# Airworthiness Directive Schedule

## Engines

### Continental

27 June 2019

DETAIL A

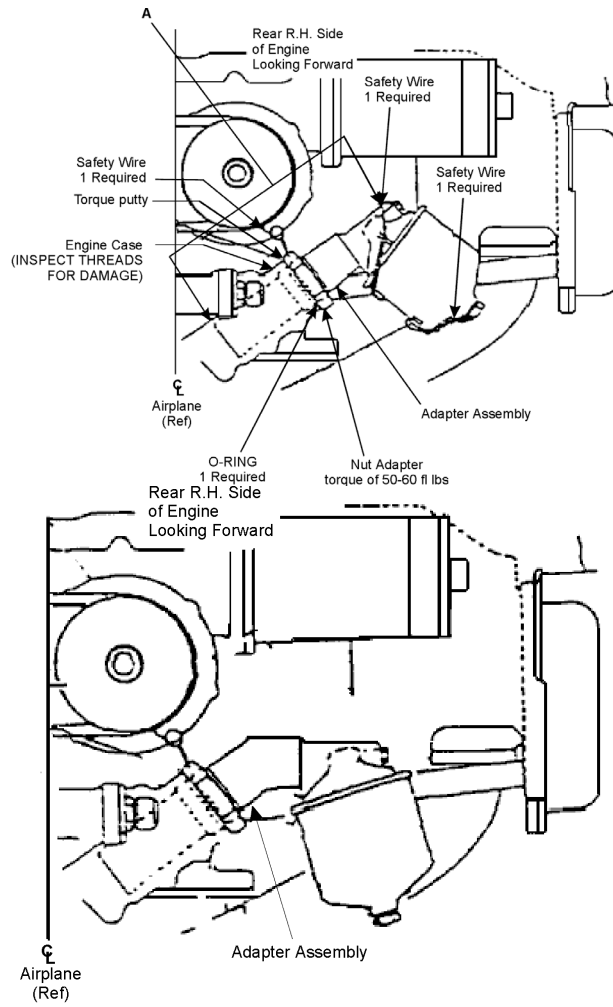
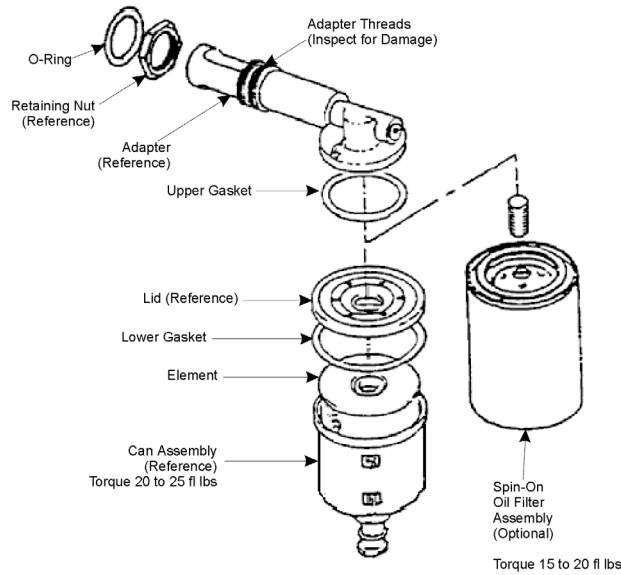
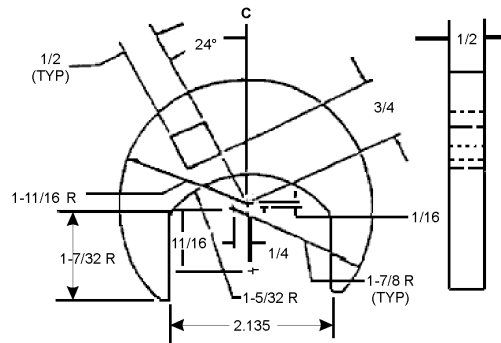
**Requirement:** To prevent loss of engine oil caused by loose or separated oil filter adapters, which could result in engine stoppage, accomplish the following:-

1. For oil filter adapter assemblies that do not have torque putty between the engine filter adapter assembly, nut, and oil pump housing, accomplish the following:

- (a) Inspect the adapter locking nut installation for evidence of oil leakage.
- (b) Check the torque of the adapter nut installation and ensure that the torque value is within the limits of 50 through 60 foot pounds.
- (c) If evidence of oil leakage is found or the torque is not within the 50 through 60 foot pound limit, prior to further flight, remove the adapter and filter assembly, and:
  - (i) Inspect the threads of the adapter assembly and engine for signs of damaged or cracked threads; and
  - (ii) Replace any adapter assembly and engine oil pump housing (if necessary) that have evidence of thread damage or cracks.
- (d) Apply torque putty between the engine filter adapter assembly, nut, and oil pump housing as specified in the diagram.
- (e) Reassemble the engine oil filter assembly.

2. For oil filter adapter assemblies that do have torque putty between the engine filter adapter assembly, nut, and oil pump housing, inspect the torque putty for misalignment, evidence of oil leakage, or cracks.

If any misalignment, evidence of oil leakage, or torque putty cracks are found, prior to further flight, accomplish the requirements specified in paragraph (1) of this AD, including all subparagraphs.
